City of Surrey PLANNING & DEVELOPMENT REPORT Application No.: 7918-0180-00

Planning Report Date: June 15, 2020

PROPOSAL:

to permit the development of a 13-storey office building with ground floor commercial retail space.

9699, 9711- 137 STREET, SURREY, BC SHEET DESCRIPTION CANODPY 1

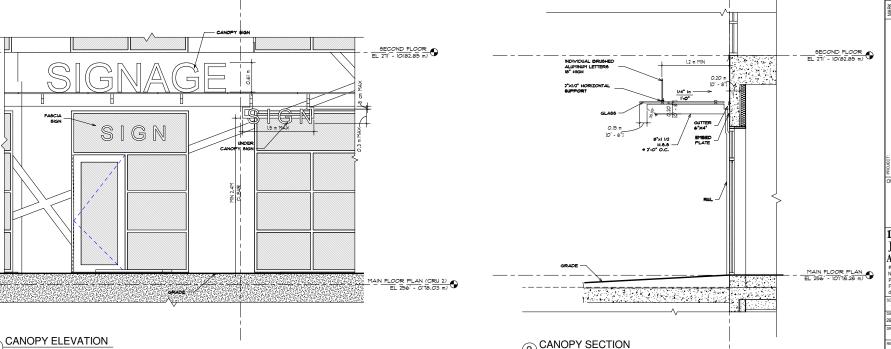
- The applicant is proposing three signage options for the commercial retail units (see drawing A4.14):
 - Canopy signage: proposed to be comprised of non-illuminated, individual brushed aluminum lettering mounted to the top of the glass canopy for each CRU. The letters would be illuminated by LED flood lights mounted to the canopy.

- o Fascia signage: proposed to integrate the fascia sign option into the CRU store front.
- o Under awning signage: proposed to allow individual channel letters to be suspended below the glass canopy weather protection for the commercial retail units.
- The proposed signage is supportable, as it has been designed in a comprehensive manner and coordinated as part of the overall design of the building.

(Signage has been revisited adding two additional sign types. Details and photos of sample signs have been added.)
